ASSESSMENT REPORT

SYDNEY SOUTH PLANNING PANEL

PANEL REFERENCE & DA NUMBER	PPSSSH-110 [DA 2022/0061]
PROPOSAL	Demolition of existing structures, remediation and construction of an 8 to 18 storey mixed use development comprising 5 buildings consisting of retail and commercial uses and 349 residential apartments over 3 basement levels
ADDRESS	Lot 30 DP 785238 - 9 Gloucester Road Hurstville
APPLICANT	GTB Hurstville Pty Ltd (c/o Sutherland Planning)
OWNER	GTB Hurstville Pty Ltd
DA LODGEMENT DATE	24 February 2022
APPLICATION TYPE	Development Application
REGIONALLY SIGNIFICANT CRITERIA	Clause 2, Schedule 6 & Cl 2.19(1) of <i>State Environmental Planning Policy (Planning Systems) 2021</i> : Development that has a capital investment value of more than \$30 million
CIV	\$164,644,165 (excluding GST)
CLAUSE 4.6 REQUESTS	Building Height – Cl 4.3(2) of the Georges River LEP 2021
KEY SEPP/LEP	SEPP 65 and Georges River LEP 2021
SUBMISSIONS – NUMBER (TOTAL & UNIQUE) & KEY ISSUES	Five (5) unique submissions raising concerns including traffic Impacts and parking, privacy and overlooking, loss of natural light, impact on view, construction management and impacts (including asbestos), building height

Figure 31: Height blanket for Buildings A and B (Source: Turner, December 2021)

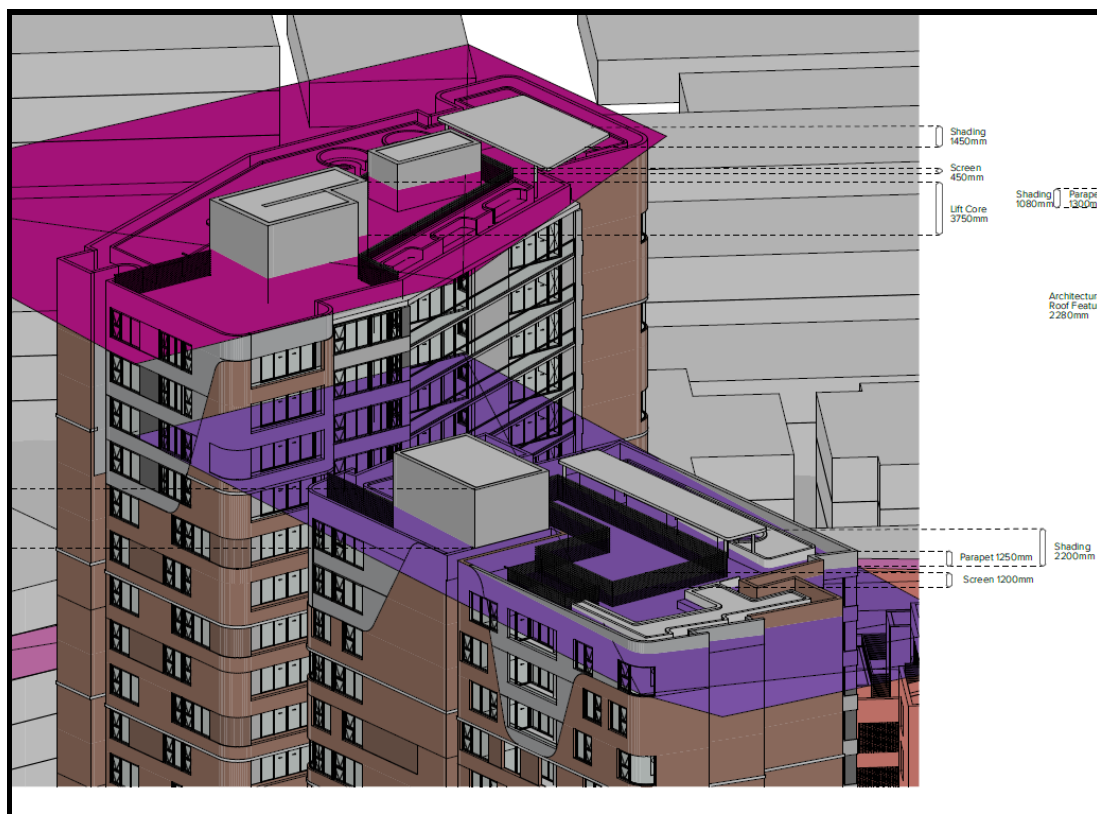
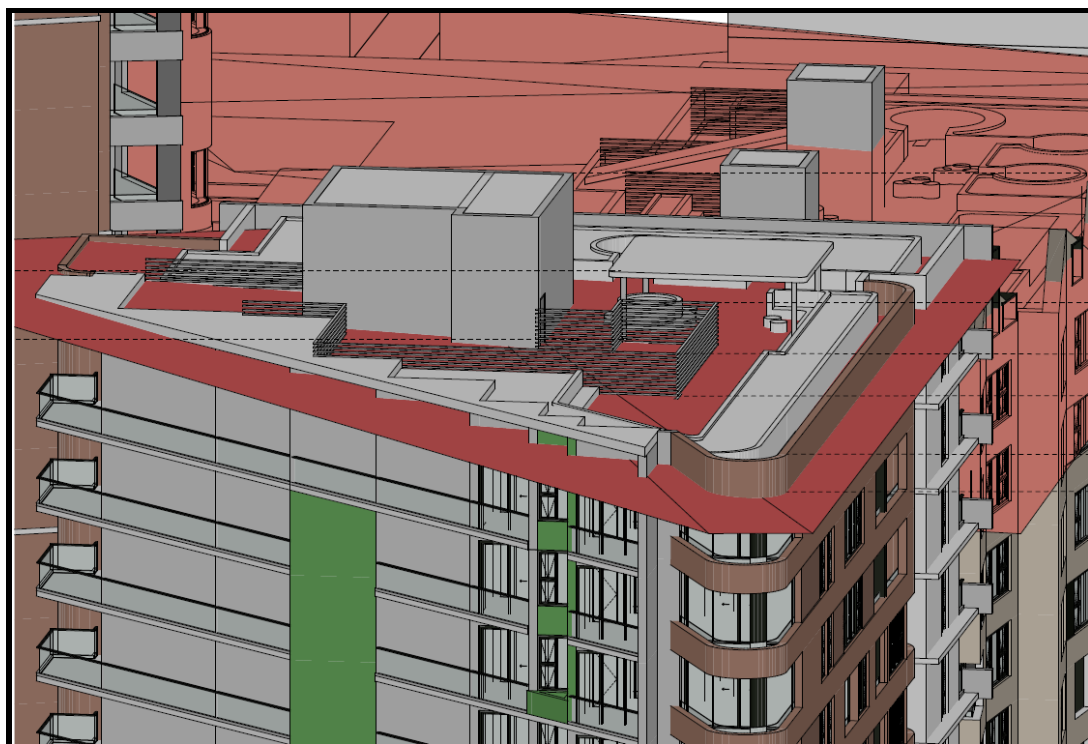
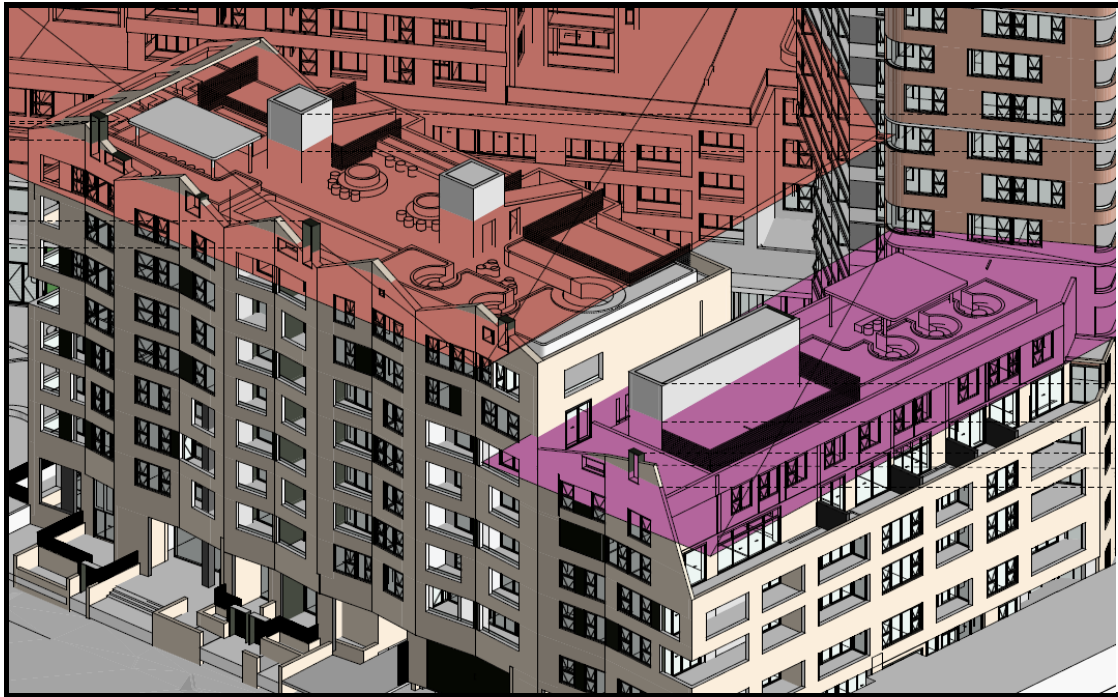
The proposal provides a number of different heights for the different buildings across the site as outlined in **Table 8**, with the proposed height exceedances from the maximum building height development standard also outlined. The height blanket for the whole site (**Figure 30**) as well as one for each of the proposed buildings provided below (**Figures 31, 32 and 33**).

Figure 39: Proposed residential lobbies for Buildings A and B (Source: Turner, March 2023)

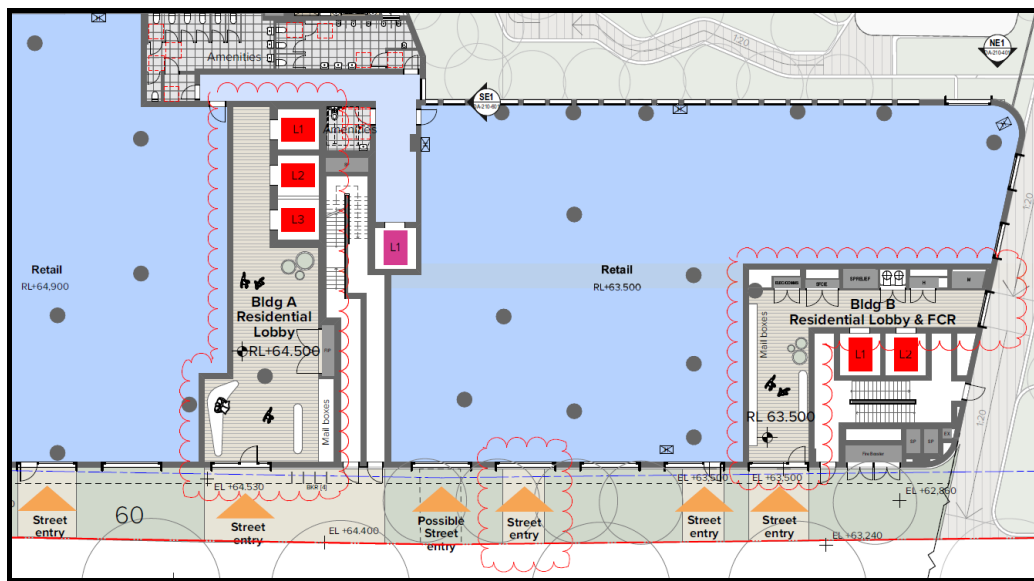
Proposed Building A comprises a residential lobby accessed from Forest Road and consists of 3 lifts, which are inset from the street with the nearest lift being approximately 12 metres from the edge of the building (**Figure 39**). The 21 metre long residential lobby is wider at the street edge (around 7.5m) and narrows down to 4.8 metres and further narrows to a 2 metre wide corridor opposite the lifts. Given the recessed nature of this area, the lift lobby does not have receive any natural light or ventilation or benefit from any significant natural surveillance from the street. This lack of amenity and surveillance may also make the space undesirable.

The narrowing and awkward shape of this lobby area also reduces the common circulation spaces which are desired to provide opportunity for casual social interaction. These concerns were raised with the applicant, however, were not addressed in the amended plans.

The Building B residential lobby includes 2 lifts as well as building services equipment in an “L” shaped configuration, with access from both the through-site link as well as Forest Road (refer Figure 39 above). There were minor changes made to this lobby area in the amended plans, however, there are still remaining concerns, including the following:

Figure 40: Proposed lobby - Building C (Source: Turner, March 2023)

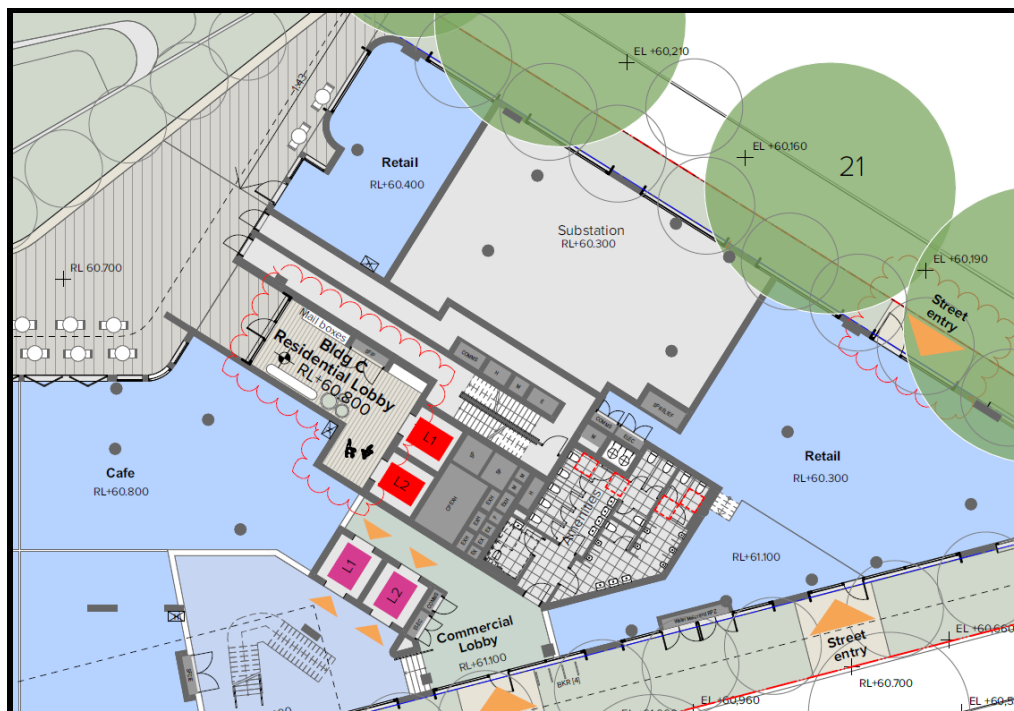
The Building C residential lobby has access from the public open space/through-site link to the north of the building (**Figure 40**). This building entry area is approximately 3.8 metres wide and is setback from the retail and service corridor façade by 3 metres. The lobby includes 2 lifts and an “L” shaped corridor with no access to natural light and ventilation.

Similar to Buildings A and B residential lobbies, safety concerns are raised due to the shape of the corridor which has a blind space. In addition, the lobby does not provide opportunity for casual social interaction. The building entry is not clearly identifiable or distinguishable arising from the small and recessed opening to this area given the length of the northern facade of Building C and the narrow width of the residential lobby entry, which results in poor wayfinding.

Figure 41: Proposed lobby for Building D (Source: Turner, March 2023)

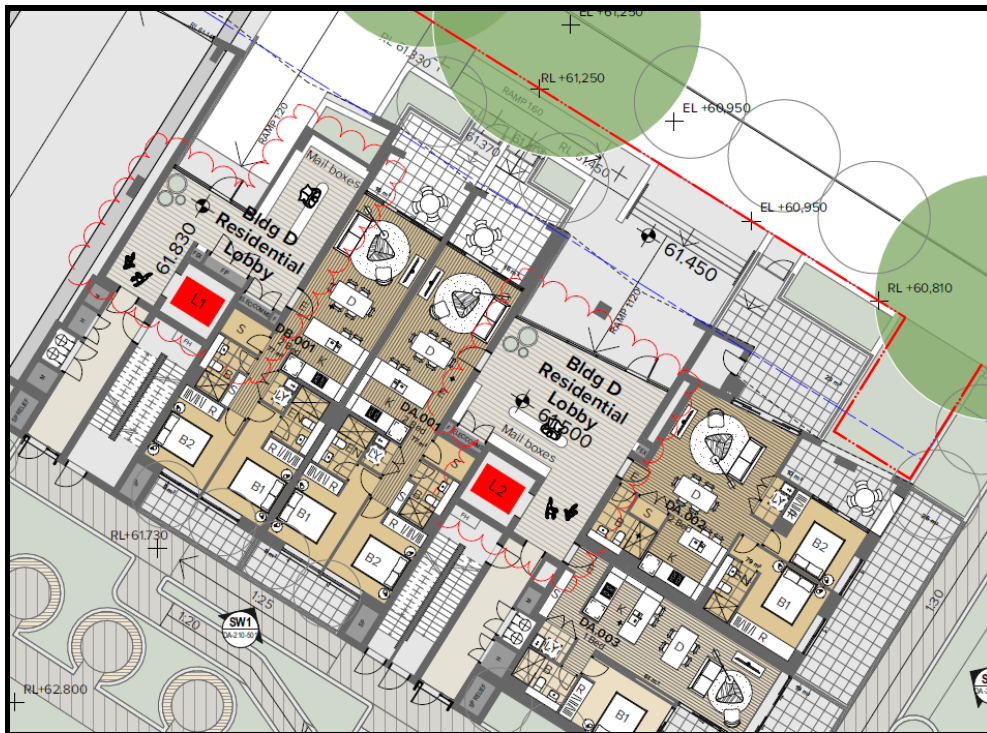
The pedestrian entry to Building D comprises two (2) separate lobby areas (west and east), and includes a convoluted combination of ramps and steps, especially the ramp for the east lobby (**Figure 41**). This area is also inset from the street frontage and the lifts face away from the entry and street. The use of the room within the front courtyard of Unit DA002 is also unclear. A single lift lobby area would be of higher amenity value to the development, which would provide for a wider area and a physical and visual connection between the entrance to the communal open space rather than the very narrow passage between the Lift L2 service stair and services.

Figure 42: Proposed Building C (Source: Turner, March 2023)

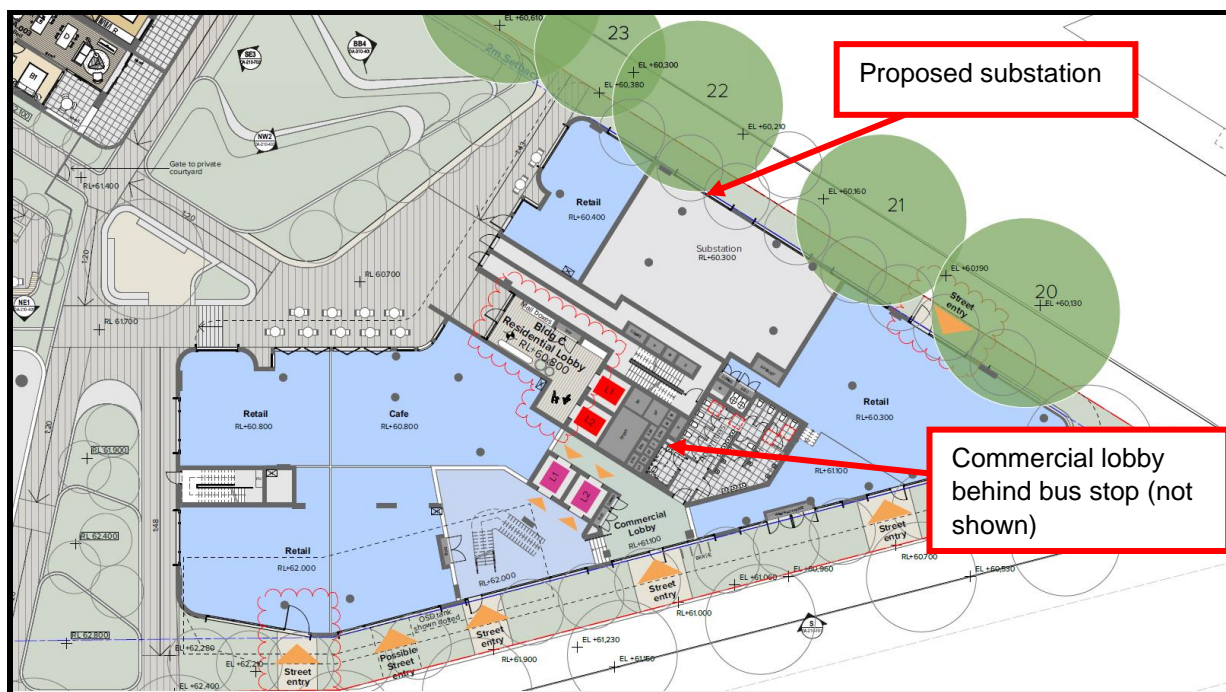
The ground floor is generally at the ground level of the street (within 100-200mm) (**Figure 42**) and the proposed retail use at the corner of Gloucester and Forest Roads adequately addresses the corner with a glazed shopfront.

Figure 43: Proposed frontage to Gloucester Road with Substation (Building C (Source: Turner, March 2023))

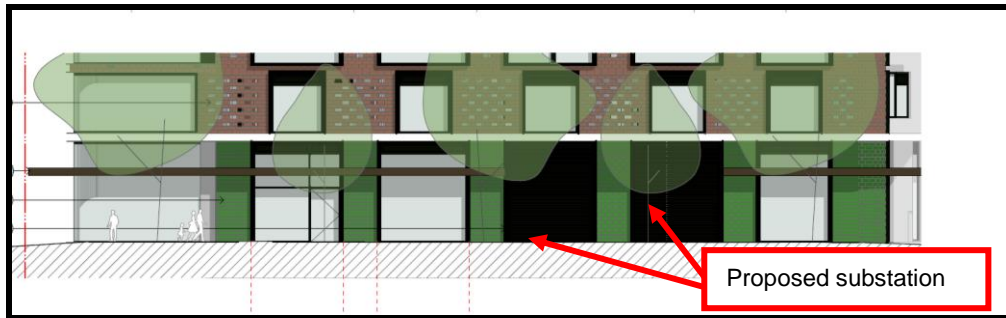
There are still some remaining concerns with the street activation for proposed Building C, including the location of the proposed substation in a prominent location along the Gloucester Road frontage (**Figure 43**). This substation, which comprises a blank façade, has an approximate width of 14 metres which represents around 35% of the frontage of the proposal to Gloucester Road, which detracts from the activation of this frontage. There are other areas on the site which could accommodate the substation, which would result in an increase in the retail space to enhance activation at this key point on the site.

Part 3C-2 of the ADG provides objectives and controls for the amenity of the public domain which is to be retained and enhanced. The current location of the substation is considered to result in a lack of street activation along this frontage which is contrary to Part 3C-2 of the ADG and is unsatisfactory.

Figure 58: Proposed root barrier adjoining the OSD Tank (Source: RPS, Drawing No DA18, March 2023)

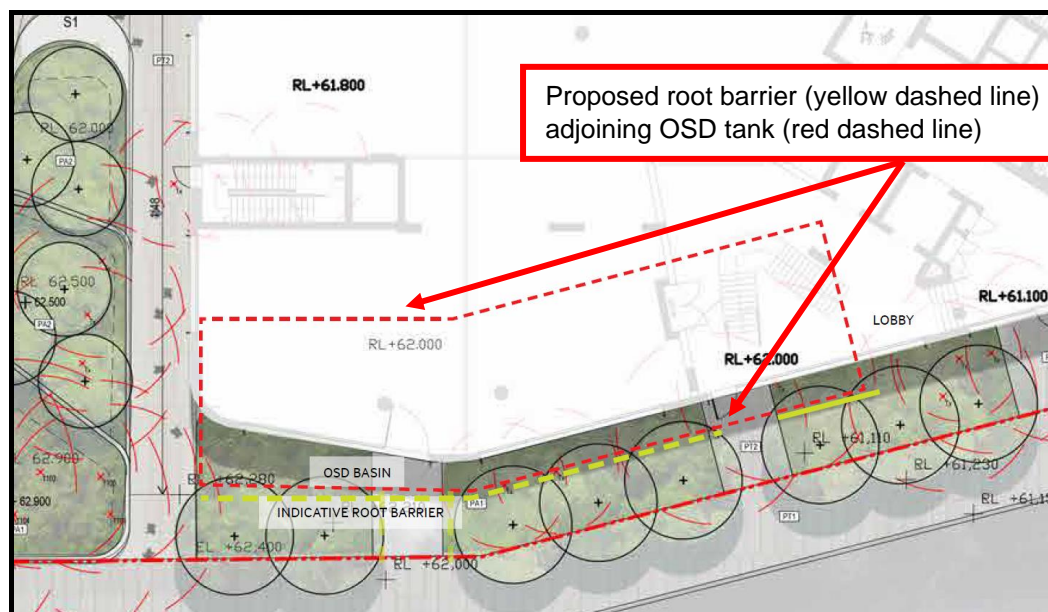
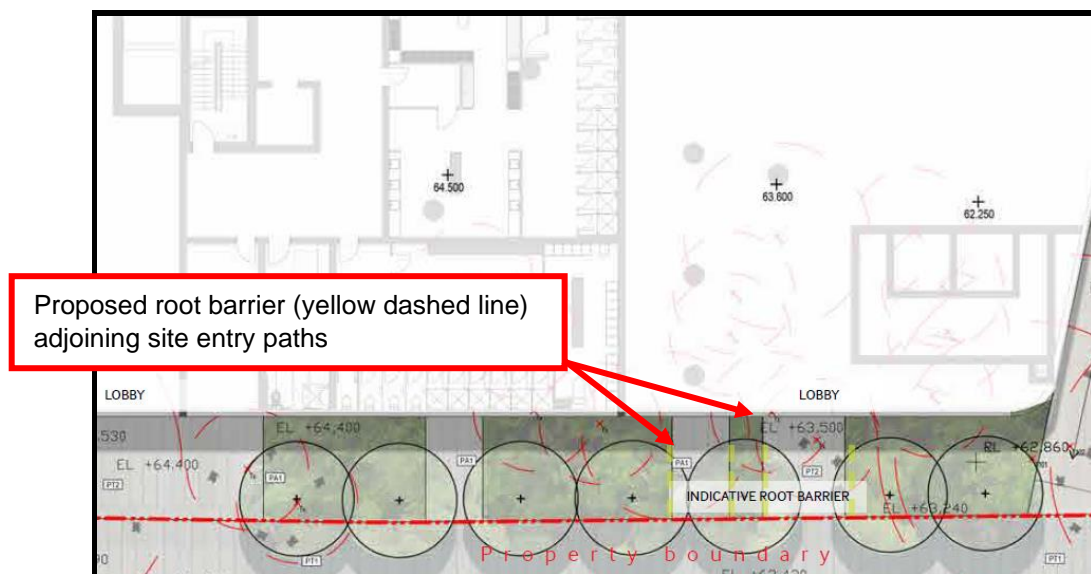
The drawings were amended to show trees are now offset 1.8m from the edge of the OSD Basin (whilst still located 1m from the back of footpath) and a root barrier has now been proposed between the trees and the basin (**Figure 58**). Root barriers are also proposed adjoining the entry areas to Building B (**Figure 59**). The tree species have also be amended and are now smaller in size, with the Lophostemon removed and water gum species (8 metres in height) now proposed in this area.

Figure 60: Proposed Tree Canopy Plan (Source: RPS, Drawing No DA22 dated 10 March 2023)

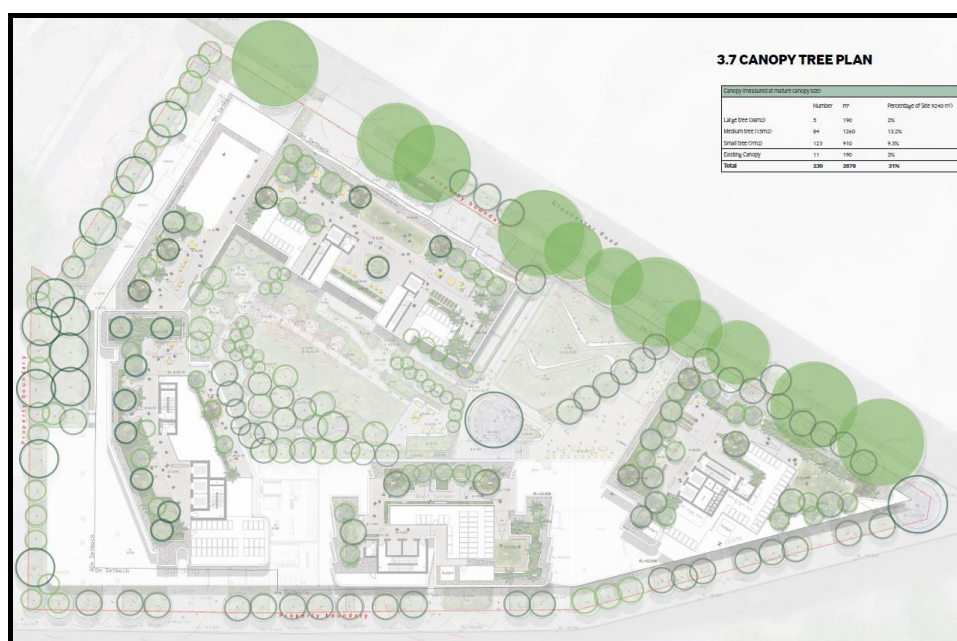
Section 8.3.3.8(b) of the HDCP No 2 requires that development must propose new trees in the locations identified in Figure 9 (illustrated above) and the proposed tree canopy must exceed the existing canopy cover on the site of 3,385sqm, which is approximately 36.63% of the site.

The landscape plan proposes trees in the approximate locations as shown in the DCP, with the tree locations designed around the proposed basement and entry areas. However, in relation to the tree canopy, the proposed canopy site coverage is 2,878m², which is 507m² under the requirement (**Figure 60**). Given the large site and the proposed density, it is considered that this tree canopy cover should be provided.

Figure 70: Proposed loading dock and bin holding room (Source: Turner, 22 March 2023)

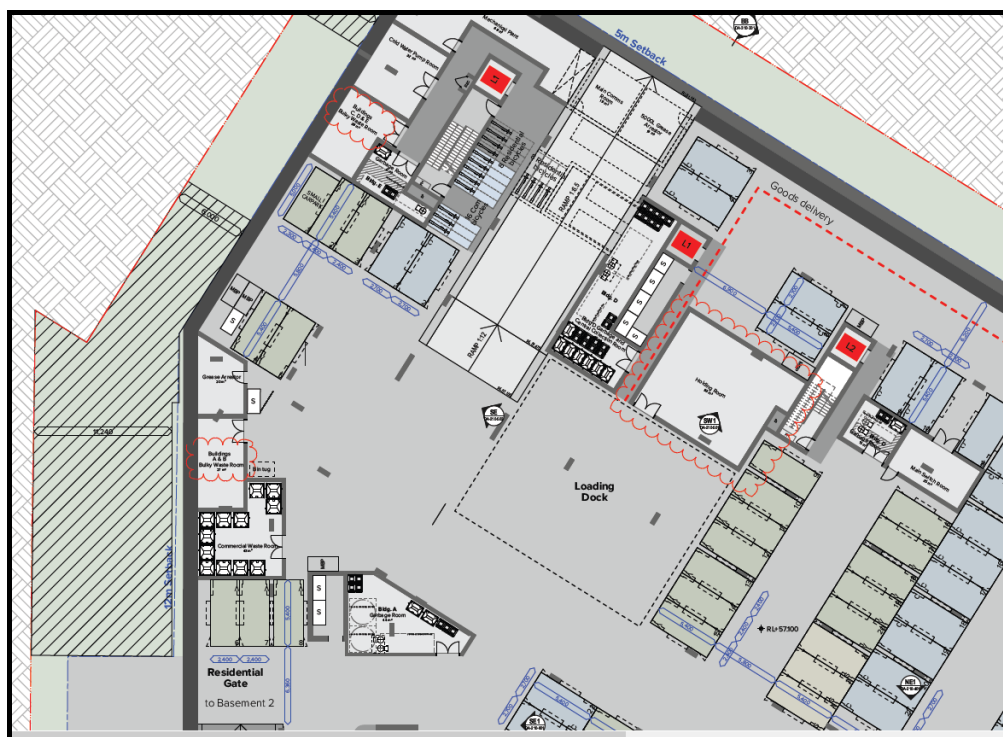
- (a) Waste rooms – The proposed bin storage rooms for each building do not provide sufficient area to store the number of waste, recycling and FOGO bins that the WMP states are required for the proposal. These concerns also arise from the lack of clarity on the architectural plans as to the number of bins to be stored in each waste room and the type/size of bins. The proposal is considered to be inconsistent with Section 6.2.4(b) of the HDCP No 2 in that the adequate common storage for waste and recyclables within each building has not been adequately provided (**Figure 70**).
